From: Scala, Mary Joy
Sent: Tuesday, September 29, 2015 2:38 PM
To: 'Clark Gathright'
Subject: RE: Chancellor building windows

In August the BAR approved the repair and replacement of the Chancellor Building windows at 1413 ½ University Avenue as follows:

CHANCELLOR BUILDING WINDOW REPLACEMENT

BAR 15-08-02

ELEVATION-NEW WINDOWS | 4K-R

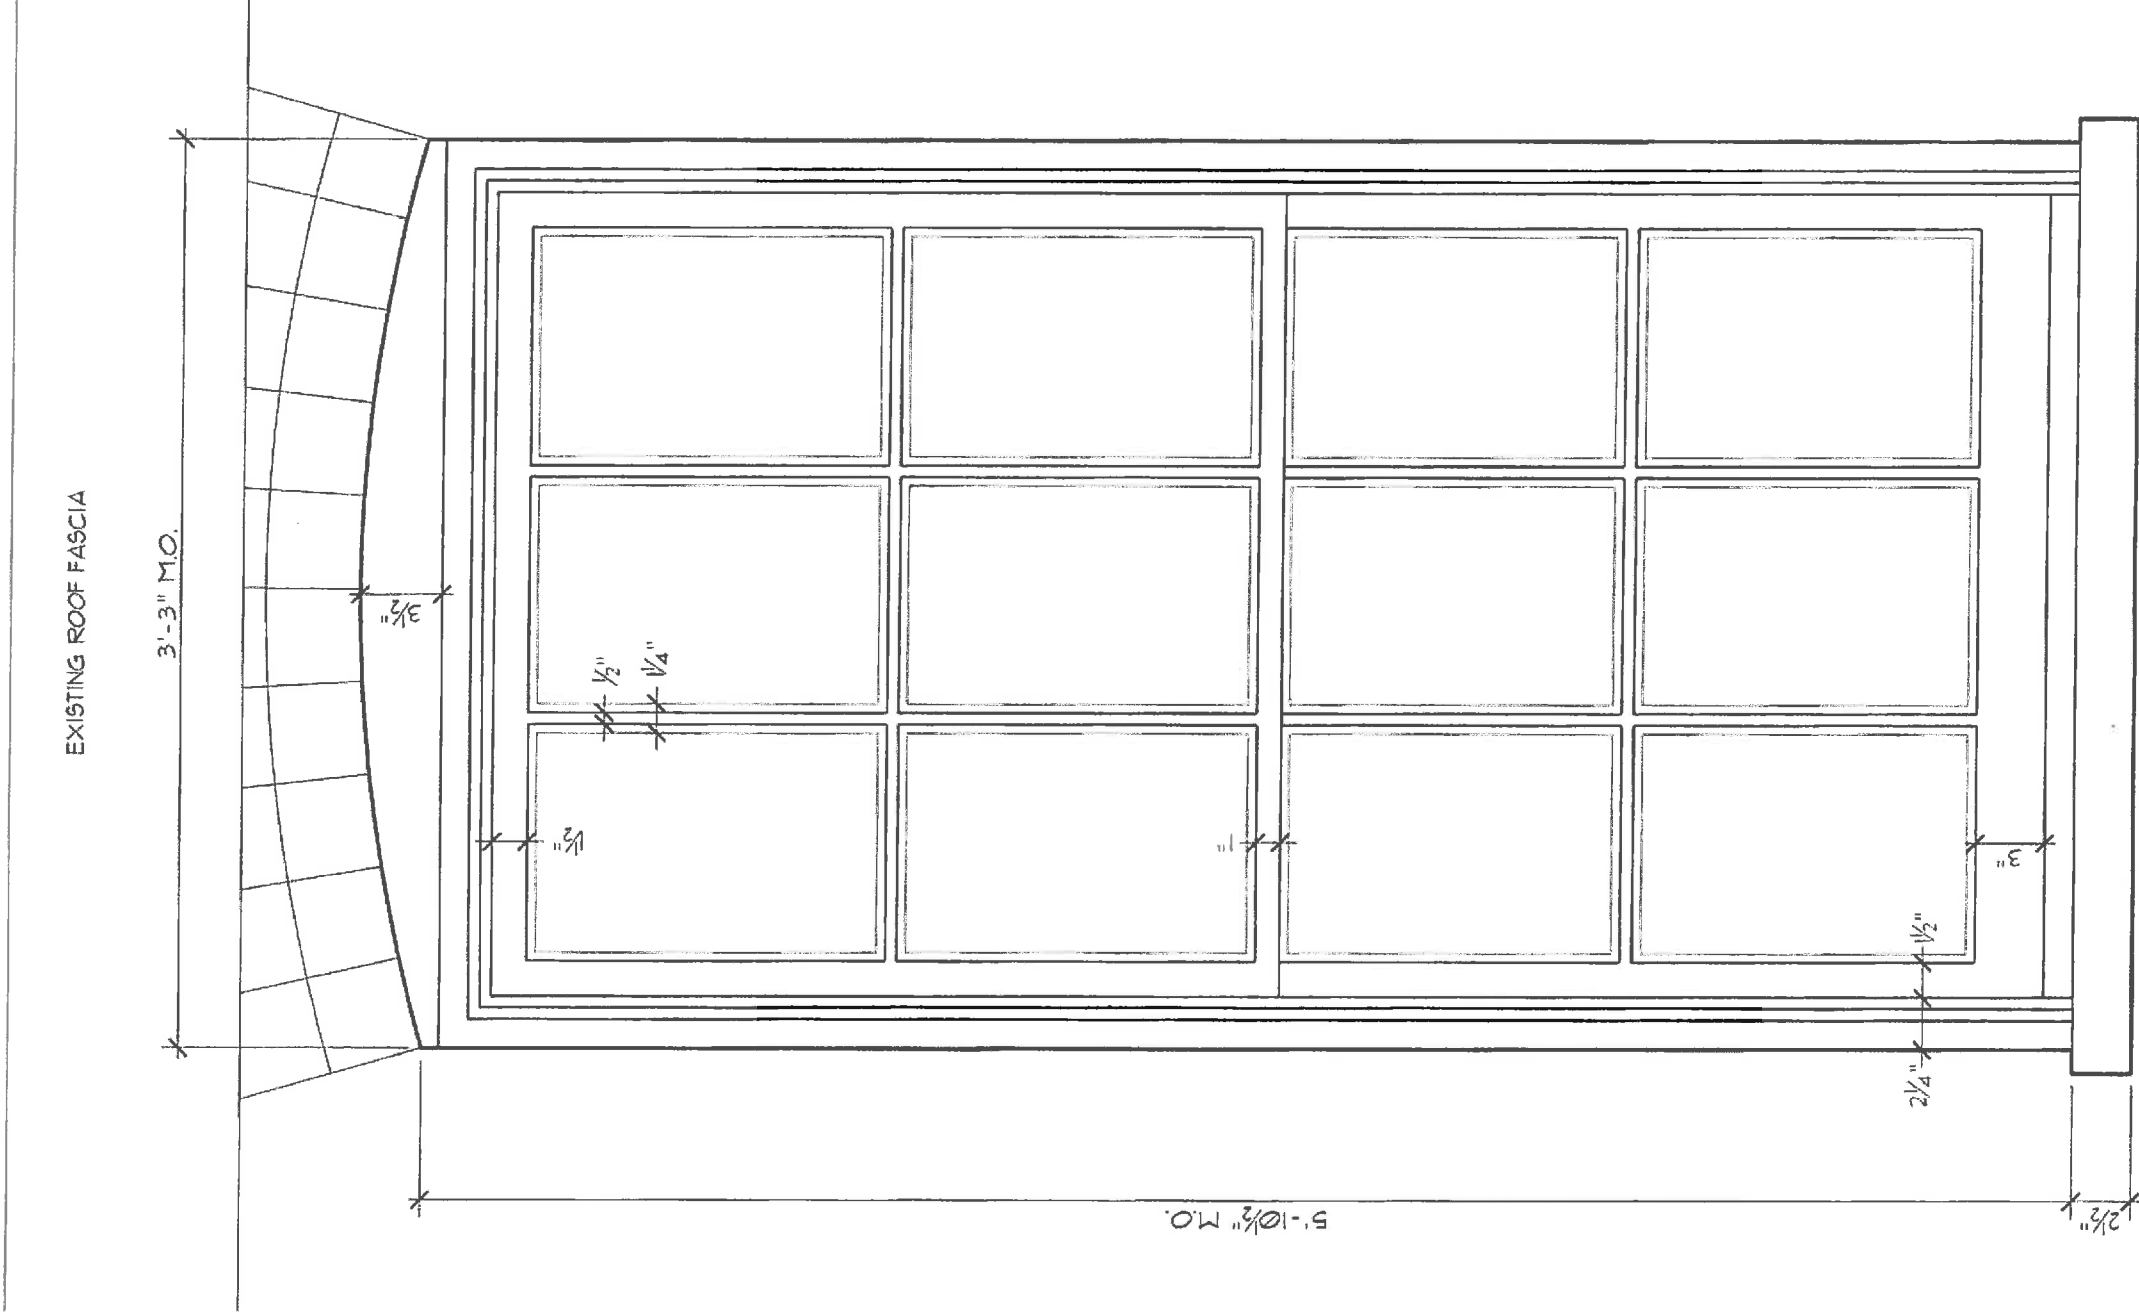
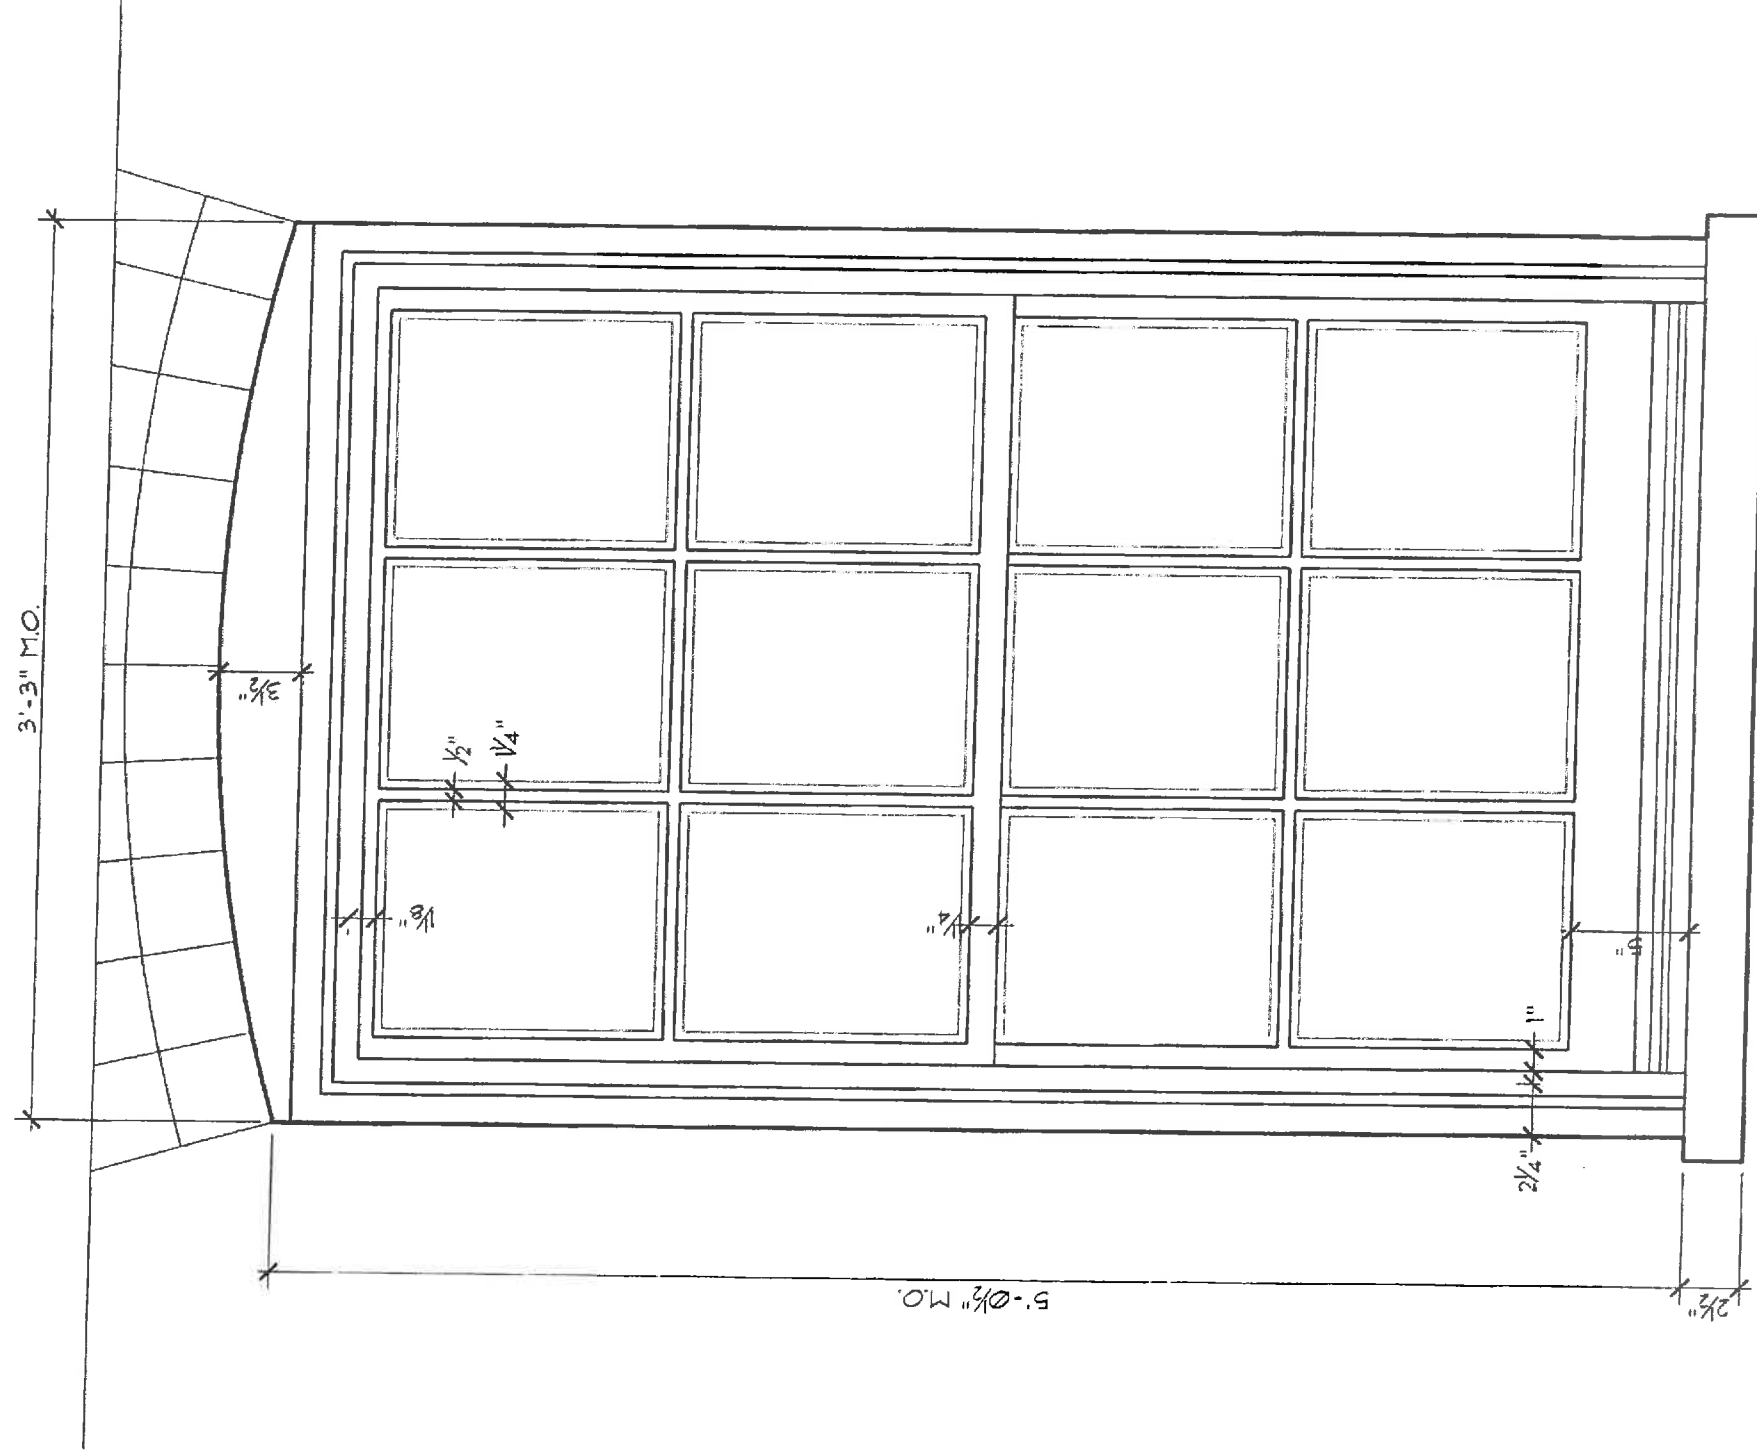
The BAR approved (6-1, with Ms. Miller opposed) to repair windows A-H, and to repair window J, and to replace the remaining windows, raising their sills above the roof membrane. The BAR requested an elevation drawing of the replacement windows in relation to the roof (comparing existing and proposed) to be circulated to the BAR for administrative approval.

(10" SHORTER THAN EXISTING WINDOWS IN ORDER
TO RAISE SILL ABOVE ROOF TERMINATION BAR.)

EXISTING REAR ELEVATION

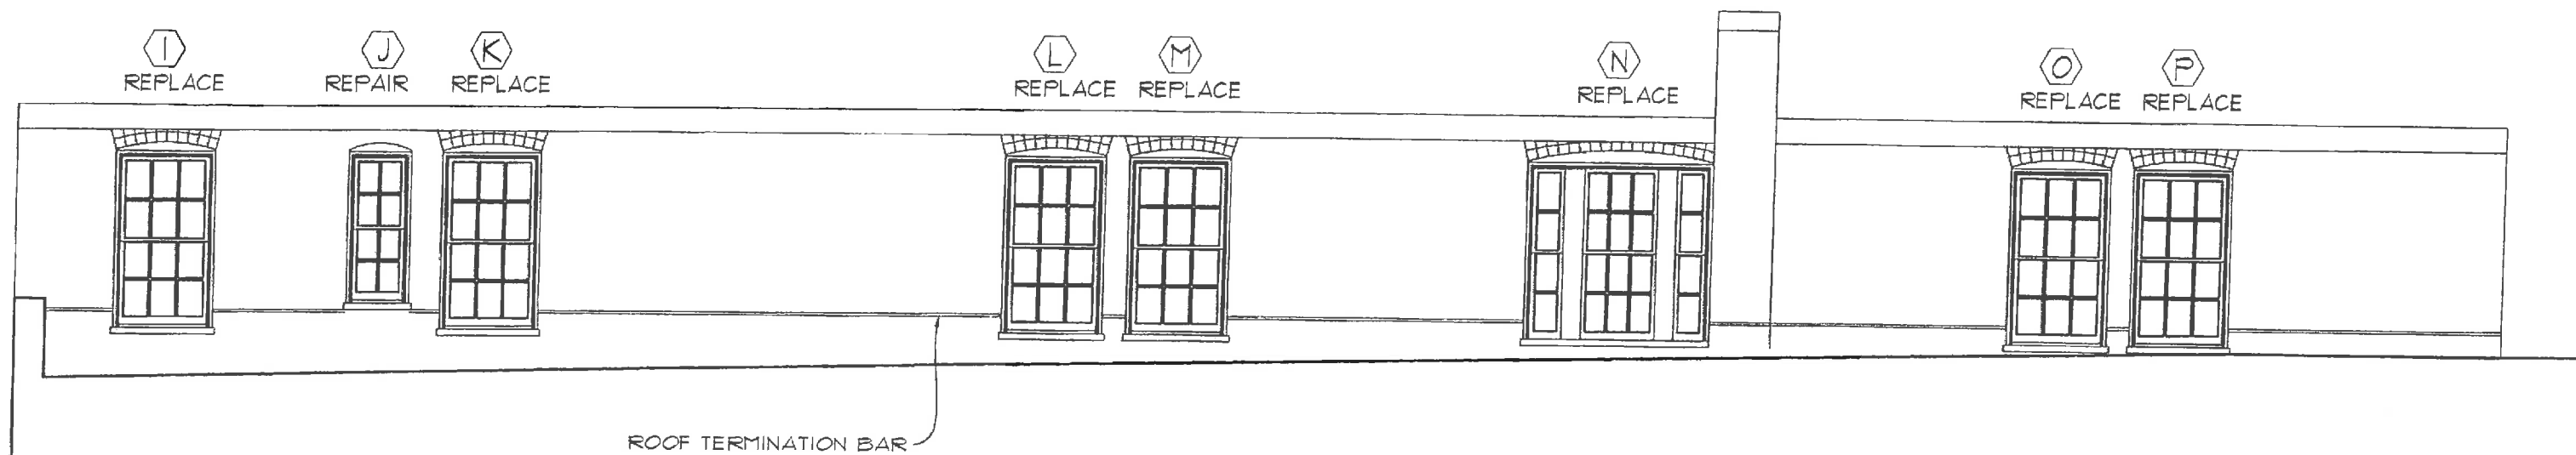
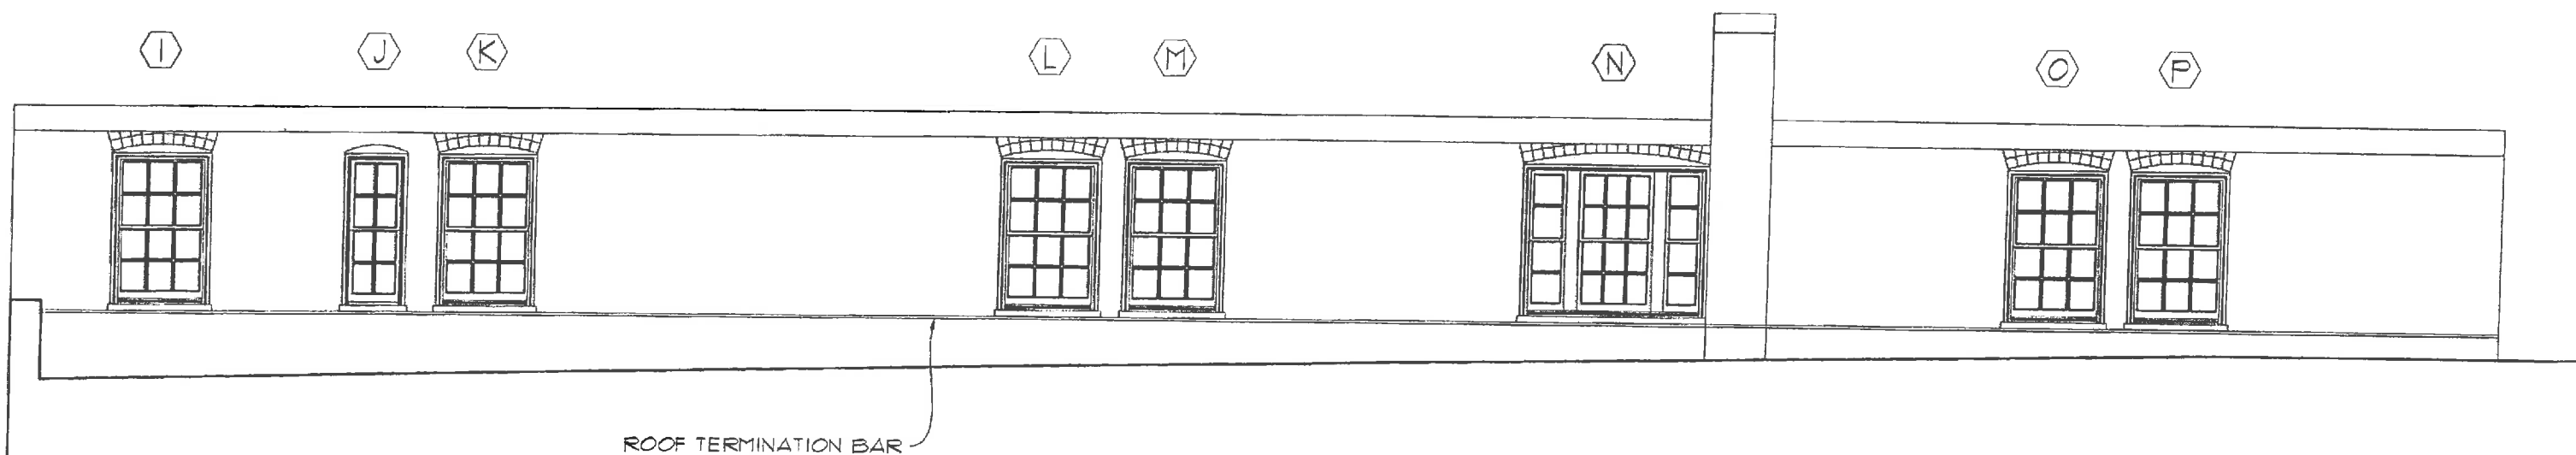
Clark, the drawings don't show the windows Q and R in relation to the roof – do you have an elevation drawing for the west elevation?

I don't. I couldn't get on that part of the roof, but the windows are the same size as the others, and the roof termination bar is lower there.

The applicant has submitted the attached drawings and is seeking administrative approval. Note the two windows on the west elevation, Q and R, do not have the problem with the roof like those on the rear elevation. Clark Gathright said they will repair those in situ.
